CERTIFICATE OF APPROPRIATENESS

Property: 1535 Arlington Street, lot 3, block 138, Houston Heights Subdivision. The property includes a historic 956 square foot, one-story wood frame single-family residence situated on a 6,600 square foot (50' x 132') interior lot.

Proposal: New Construction – Construct a two-story detached front-loading garage measuring 24' wide by 22' deep with a 26' ridge height at the rear of the lot.

EAST ELEVATION – FRONT FACING ARLINGTON STREET

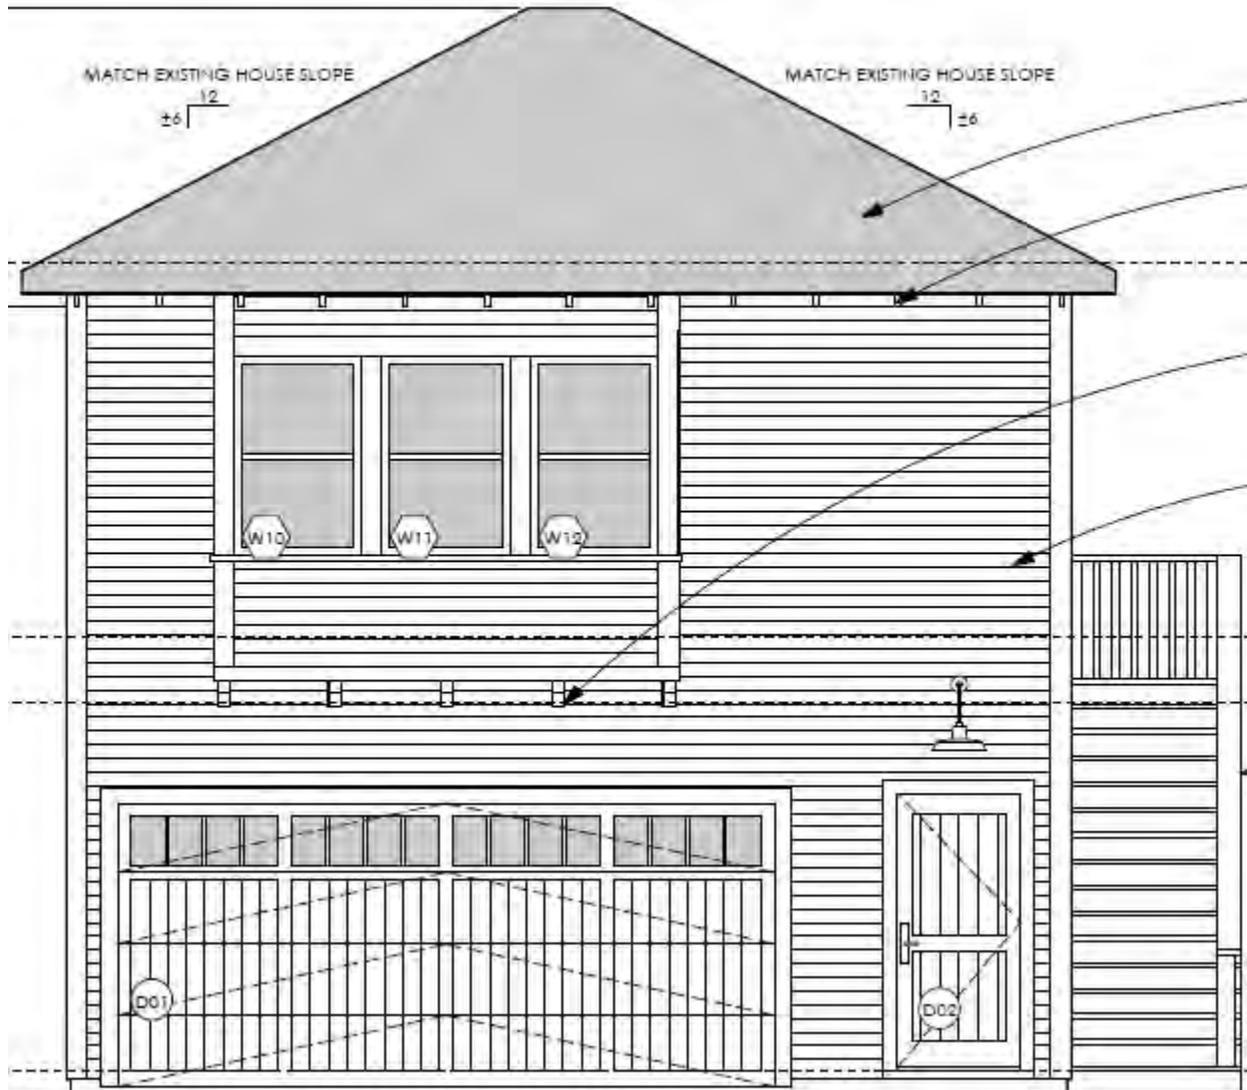
I think this would look much better if there were windows on the street-facing side of the second-story addition. It looks closed and disconnected without those windows.
